UNITED STATES PATENT AND TRADEMARK OFFICE

10/779,683

Office Action Summary	Application No.	Applicant(s)	
	10/779,683	KANAI, MASAHIRO	
	Examiner	Art Unit	
	Alexander Sofocleous	2824

DETAILED ACTION

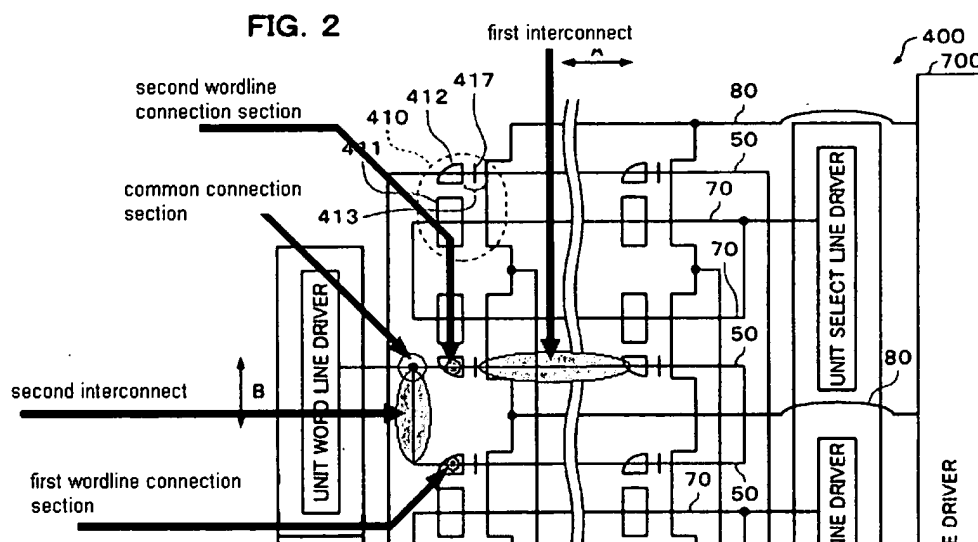
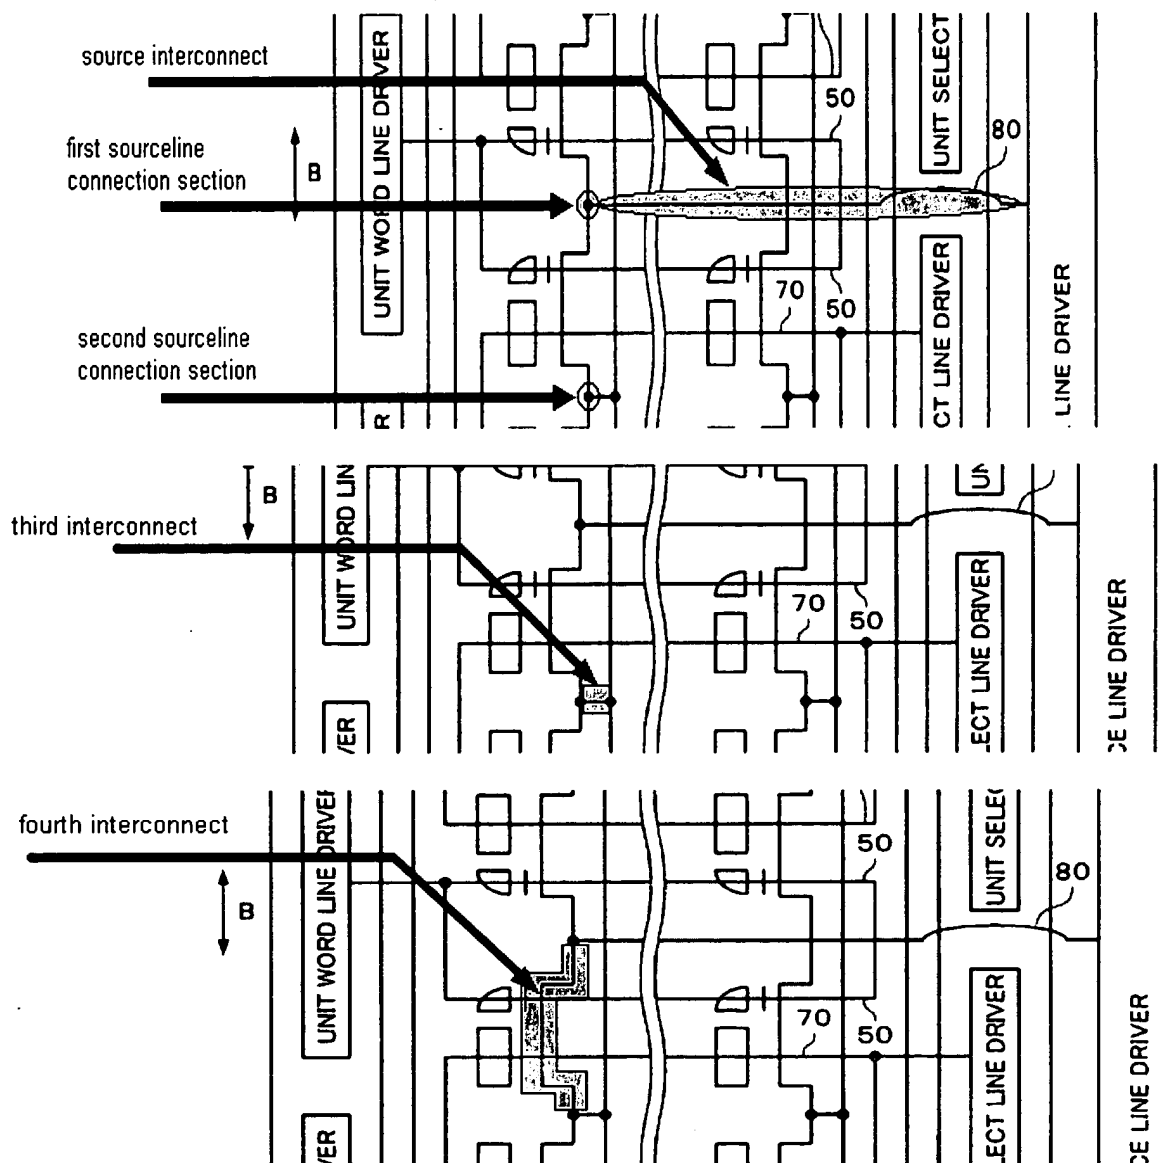
A plurality of common connection sections connect two of the word-gate rows adjacent in the column direction over on of the element isolation regions on which the first wordline connection section is disposed (see Fig. 2 with respect to (Fig. 5 [412 with respect to STI])). See reproduction of Fig. 2 below, as marked up by Examiner to indicate unlabeled points.

Regarding dependent claim 4, Natori shows the first wordline connection section connects at least one of the word gate interconnects (Fig. 2 [50]) with one of the common connection sections (see Fig. 2). See reproduction of Fig. 2 on page 6 of this Office Action, as marked up by Examiner to indicate unlabeled points.

A plurality of common connection sections connect two of the word-gate rows adjacent in the column direction over on of the element isolation regions on which the first wordline connection section is disposed (see Fig. 2 [50] with respect to (Fig. 5 [412 with respect to STI])). See reproduction of Fig. 2 on page 6 of this Office Action, as marked up by Examiner to indicate unlabeled points.

A second wordline connection section which connects one of the common connection sections with the second interconnect is disposed over at least one of the element isolation regions (see Fig. 2[50] with respect to (Fig. 5 [412 with respect to STI]). See reproduction of Fig. 2 below, as marked up by Examiner to indicate unlabeled points.

Regarding dependent claim 7 and 9, Natori shows a first wordline connection section including a second wordline connection section (see Fig. 2 [50]). See reproduction of Fig. 2 above, as marked up by Examiner to indicate unlabeled points.

Regarding dependent claim 11 and 13, Natori shows the source interconnect includes a third interconnect extending along the row direction and a fourth interconnect extending along the column direction (see Fig. 2 [80]) wherein the first source line connection section includes a second source line connection section which connects the third interconnect with the fourth interconnect (see Fig. 2 [80]). See reproduction of Fig. 2 below, as marked up by Examiner to indicate unlabeled points.
